RESEARCH REACTOR CENTER

REFERENCE: Docket 50-186
University of Missouri-Columbia Research Reactor
Amended Facility License R-103

SUBJECT: Written communication as specified by 10 CFR 50.4(b)(1) regarding the response to the "University of Missouri – Columbia – Request for Additional Information, Re: License Amendment, Center Test Hole (TAC No. ME1876)," dated July 1, 2011

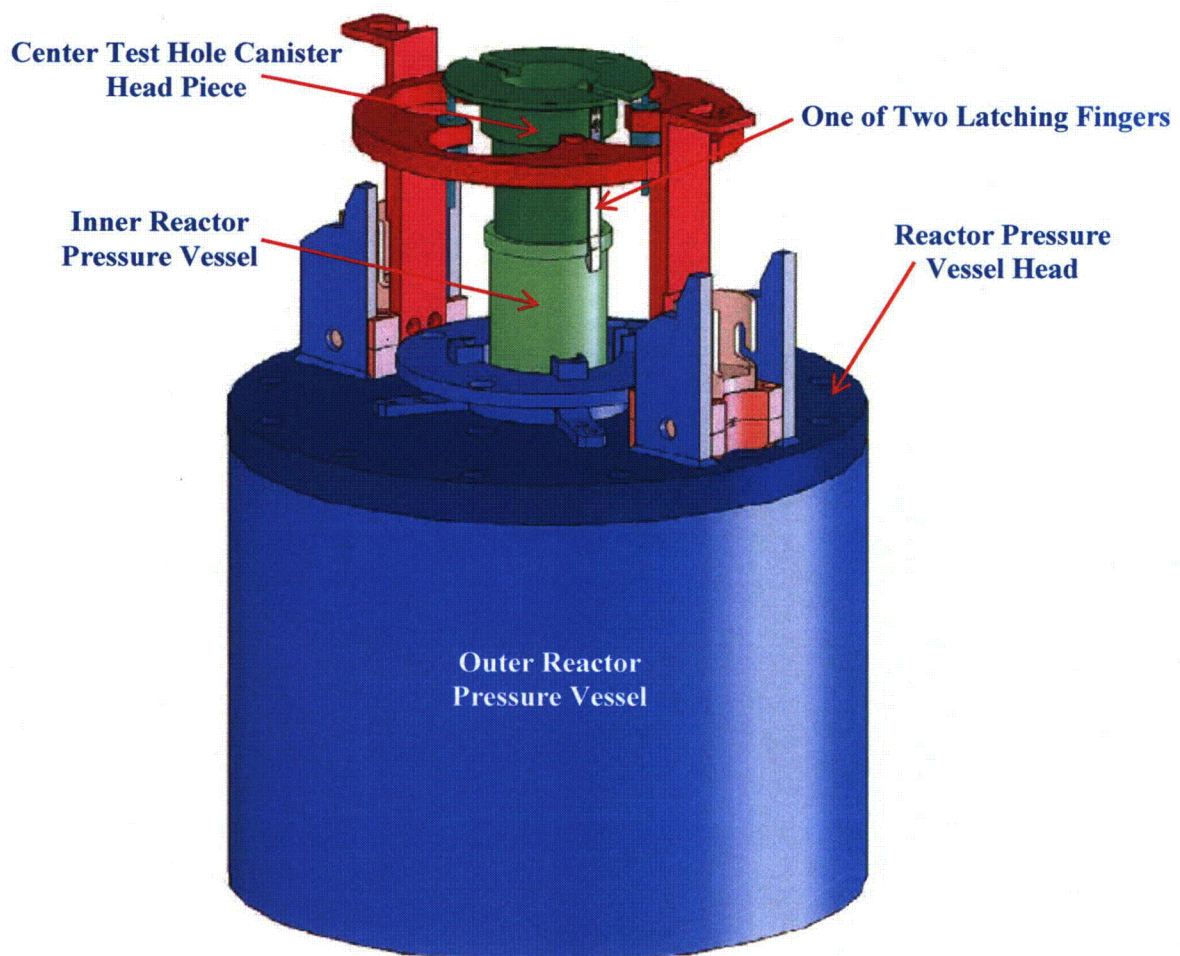
- a. *The center test hole canister is held in place by two Inconel metal latching fingers. In the event of the failure of one of the fingers, can a single finger hold the canister in place under normal operations conditions? Please provide details.*

The following is a description of the center test hole canister latching mechanism: When installed, the center test hole canister position is positively determined by a latching mechanism located at the top of the assembly. The latching mechanism consists of two Inconel metal fingers which secure the canister to the upper portion of the inner reactor pressure vessel. The fingers, which are attached to the upper section (head piece) of the canister by four (two per finger) countersunk, stainless steel screws, are positioned 180 degrees apart and are totally independent of one another. In order to provide additional vertical alignment and support, the canister base piece engages into a test hole slot which is welded to the reflector tank base flange. The center test hole canister latching mechanism and method of vertical alignment and support have not been modified or altered from its original design and no failures have occurred in the nearly 45 years of operation.

The condition of the latching fingers and stainless steel screws are closely inspected at least twice a week – first, when the canister is removed after the reactor is shutdown in order to retrieve the irradiated samples and second, before it is reinserted into the inner pressure vessel after new samples have been loaded into the canister.

In the extremely unlikely event of a failure of a single latching finger, the other finger can hold the canister in place under all operating conditions. One latching finger fully meets the intent of the definition of a Secured Experiment (MURR Technical Specification 1.24), which states, “A secured experiment is any experiment which is rigidly held in place by mechanical means with sufficient restraint to withstand any anticipated forces to which the experiment might be subjected.”

Additionally, the overall length of the center test hole canister is 170.25 inches and it is positioned vertically within the 4.5-inch inside diameter inner reactor pressure vessel. The weight of the center test hole canister, gravity and a downward pool coolant flow rate of approximately 100 gallons per minute through the inner reactor pressure vessel collectively aid to provide additional downward force to maintain the canister in place under all operating conditions.

Six-Tube Center Test Hole Canister

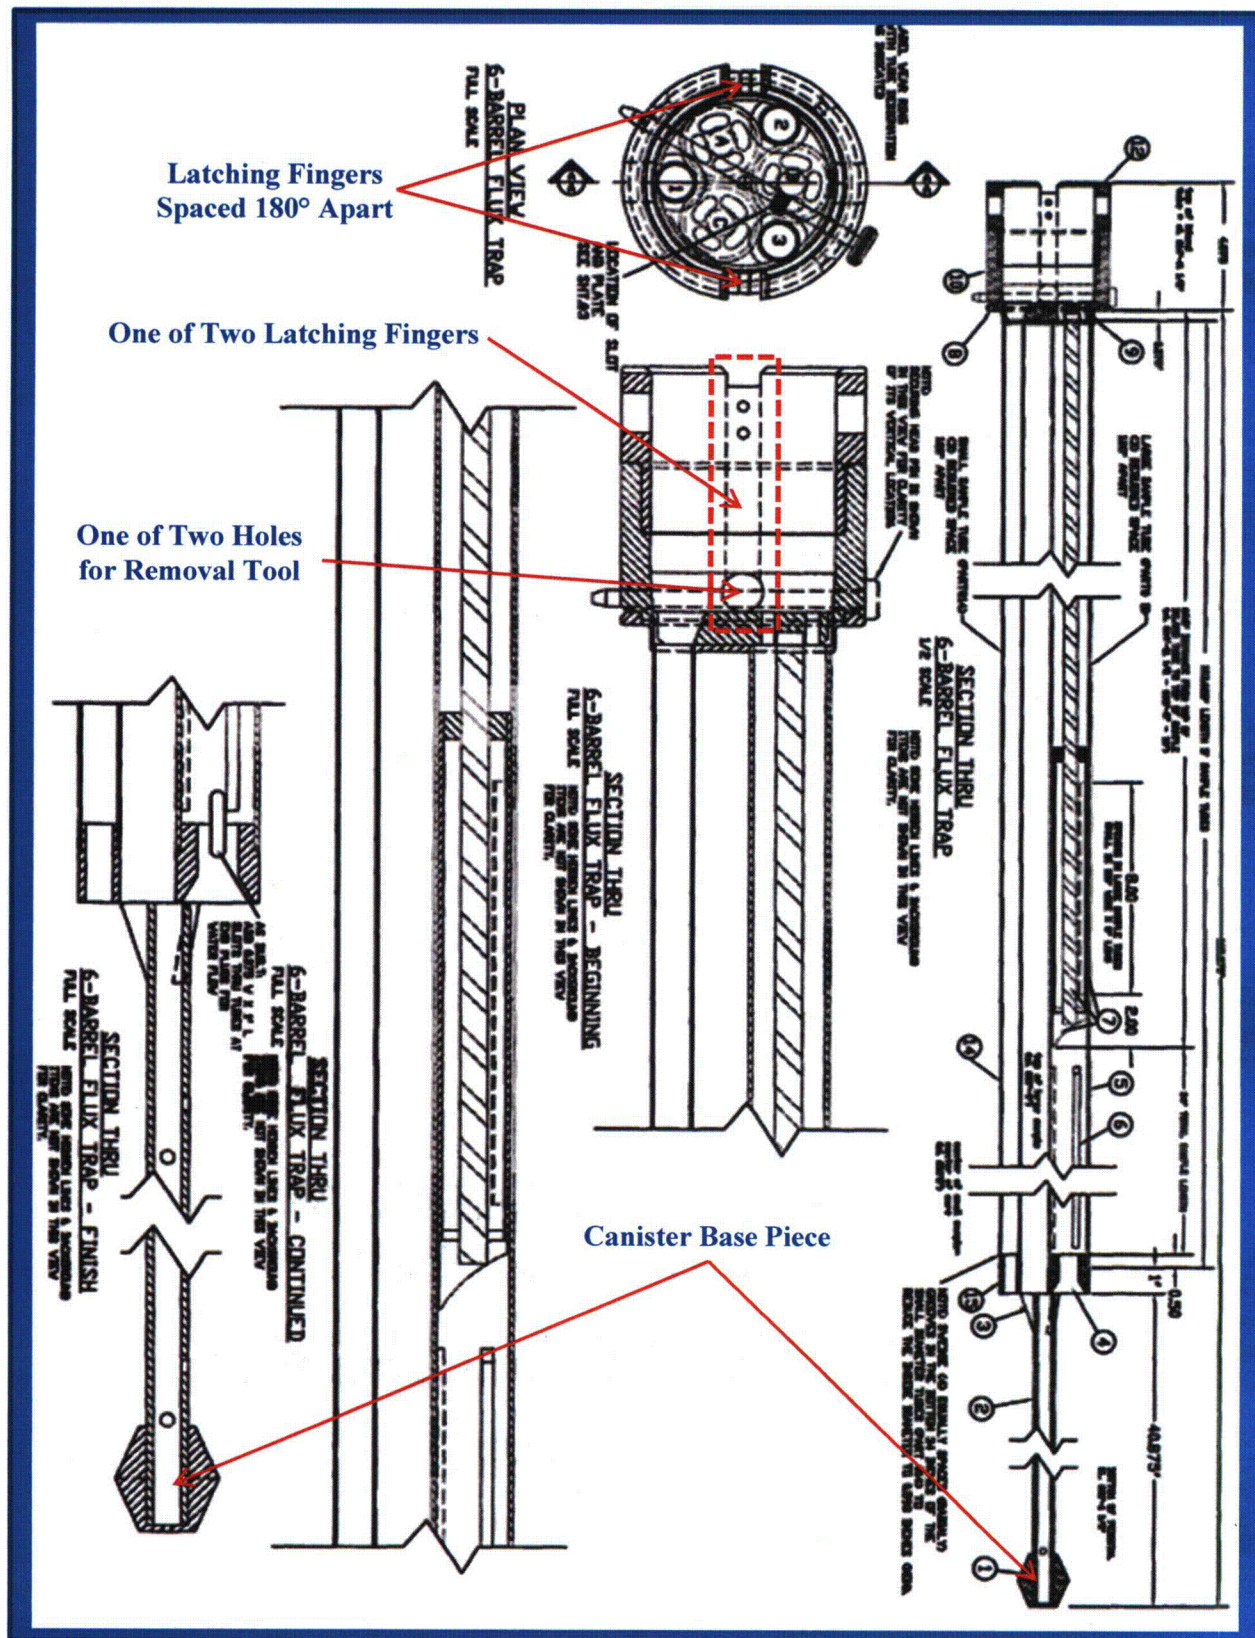
c. The application states that it is “highly unlikely” that an operator could inadvertently remove a fully loaded center test hole canister while at power. Please provide further justification and a description of controls to validate this conclusion, or provide justification and a description of controls to validate this conclusion, or provide an analysis that demonstrates that the reactor can be safely shutdown following a reactivity insertion from the removal of a fully loaded center test hole without violating the safety limit for power.

The design of the center test hole canister latching mechanism is described in detail above. The latching mechanism, consisting of two separate, independent latching fingers, provides a redundant, positive latch of the center test hole canister to the inner reactor pressure vessel. Additionally, a special removal tool, with an overall length of approximately 20 feet, is required to unlatch and remove the center test hole canister from the inner pressure vessel. The head of the removal tool must be inserted into the center test hole canister wear ring in order to spread the latching fingers sufficiently to disengage the canister from the inner pressure vessel. Knowledge of the tool's operation, in addition to the skill that is required to operate the tool under nearly 17 feet of pool water, also helps to prevent the inadvertent removal of the center test hole canister while the reactor is operating.

Finally, the proposed Flux-Trap Irradiations Reactivity Safety Trip (FIRST) device would prevent the insertion of positive or negative reactivity from either the insertion or removal of the center test hole canister because (1) the reactor cannot be started up without the center test hole canister or strainer inserted and latched, and (2) removal of the center test hole canister while at power will cause a reactor scram. Because of the redundant FIRST device sensor switches, the reactor would immediately shutdown (less than 0.7 seconds for all four control blades to be inserted greater than 80% from their fully withdrawn positions – approximately 91% of the total blade worth is inserted at this level) if the center test hole canister moved outward less than 1/4-inch (maximum travel of the sensor switches). It should also be noted that because of the positive void coefficient of the flux trap region (approximately $+0.865 \times 10^{-5} \Delta K/K/cc$ void), removal of the center test hole canister would insert negative reactivity into the core.

Because of the FIRST device, insertion of positive or negative reactivity from either the insertion or removal of the center test hole canister while the reactor is operating is no longer considered a credible accident. The only credible accident is the failure of a single experiment in the center test hole. The worst case scenario is the sudden bursting of a sample can and the resulting discharge of its contents, with the possible damage to an adjacent sample can. Experiments in the center test hole will continue to be limited by Technical Specification 3.1.h such that the failure of any single experiment cannot introduce a reactivity change of greater than $0.006 \Delta K$. The transient analysis for 10-MW operation to determine the maximum safe step reactivity insertion is described in Section 3.5 of Addendum 3 to the Hazards Summary Report (Attachment 5). The analysis shows that the MURR can withstand a rapid step reactivity insertion of $0.007 \Delta K$ with no core damage.

Simplified Diagram of FIRST Wiring Scheme with Two Bypass Switches

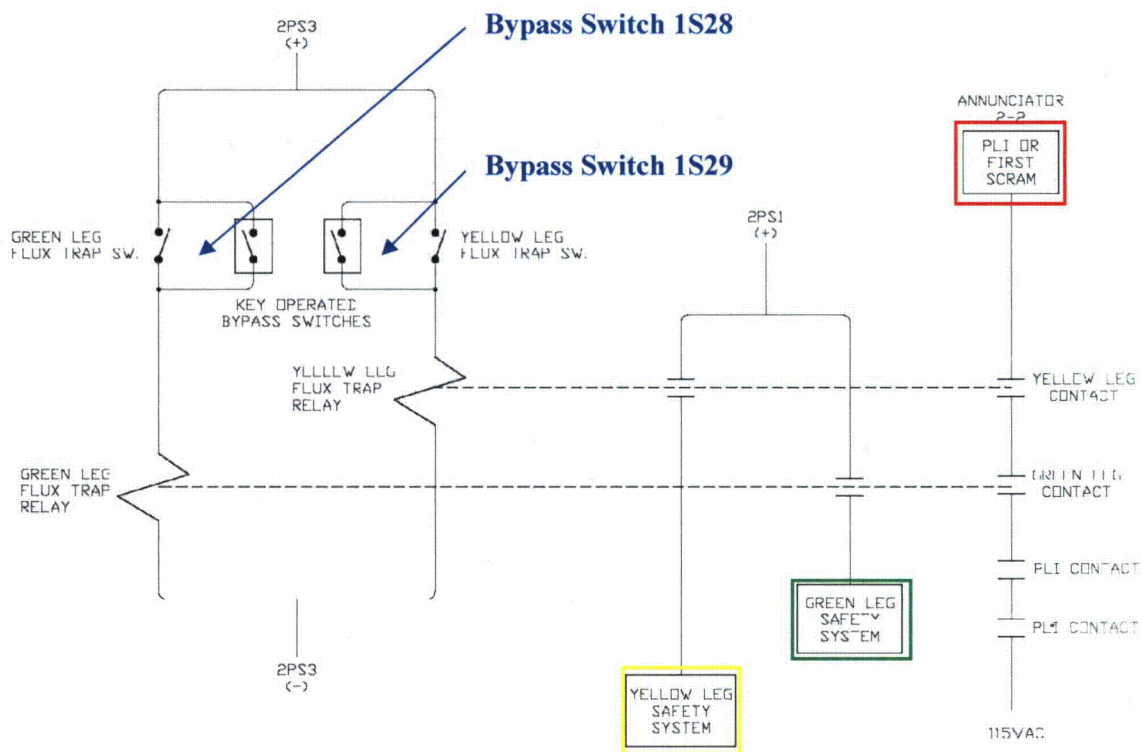
2. *The bypass key circuit controlling the FIRST instrument channels provides a point of single failure. Please propose changes to address the single failure issue or provide justification as to why this condition is acceptable.*

While it was previously argued that the bypass key circuit controlling the FIRST instrument channels would not provide a point of single failure (Answer to RAI question No. 5, dated January 31, 2011), MURR is proposing the following change to further ensure that a single failure scenario cannot occur.

MURR will implement a second bypass key switch, identical to the original bypass key switch such that each of the two instrument channels will have an independent bypass switch. This second switch, designated 1S29, will be mounted on the reactor control console adjacent to the originally proposed switch, designated 1S28. Where the original 1S28 switch used two separate contact blocks, each switch will now use only one contact block.

The addition of a second bypass switch will not alter the way the instrument channels function electrically from what was originally proposed in the Amendment application. Additionally, the bypass switches will also provide the same following two functions as previously stated: (1) allow testing and troubleshooting capability, and (2) provide the use of both the proposed methodology and the current methodology for calculating the reactivity contribution of samples and the center test hole canister in the flux trap region. The bypass keys will be controlled administratively as previously described:
